**AMENDMENTS TO THE DRAWINGS:**

**REMARKS**

U.S. Application Serial No.: 10/623,540  
Attorney Docket No. 1015290-000661  
Amendment Responsive to Office Action dated February 15, 2006  
filed on May 12, 2006  
Annotated Drawing Sheet 1 of 1

FIG. 10

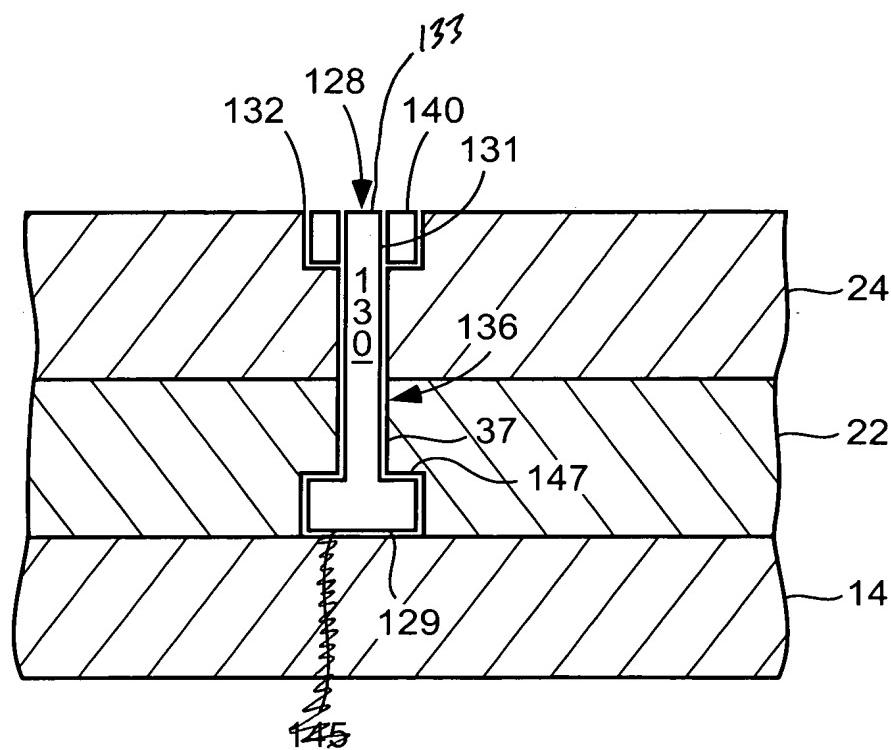
At numbered point (2) of the Official Action, it is asserted that reference character "131" has been used to designate the "upper portion," "threads" and "external threads." To address this objection, Applicants propose to amend Figure 10 to add the reference number 133 to indicate the location of the "upper portion." The specification is amended to be consistent with revised Figure 10.

At numbered point (3) of the Official Action, it is asserted that reference characters "128," "130," "131" and "136" have been used to designate the fastener member 128. As described at paragraph [0041] of the specification, the fastener member 128 includes a shaft 130 and external threads 131. In FIG. 10, the reference number 128 indicates the fastener member generally, while reference numbers 130 and 131 indicate specific portions of the fastener member 128. As described at paragraph [0041], the aperture 136 is in the backing plate 22, but is not part of the fastener member. Applicants submit that FIG. 10 is acceptable.

At numbered point (4) of the Official Action, it is asserted that reference number 145 is not mentioned in the description. Applicants propose to amend

Figure 10 to delete reference number 145 and its associated lead line to address this objection. This amendment to Figure 10 also addresses the objection stated at numbered point (5) of the Official Action.

The attached sheet of drawings includes changes to FIG. 10. This sheet, which includes FIGs. 9 and 10, replaces the original sheet including these same figures. In FIG. 10, reference number "133" and an associated lead line are added, and reference number "145" and an associated lead line are deleted.
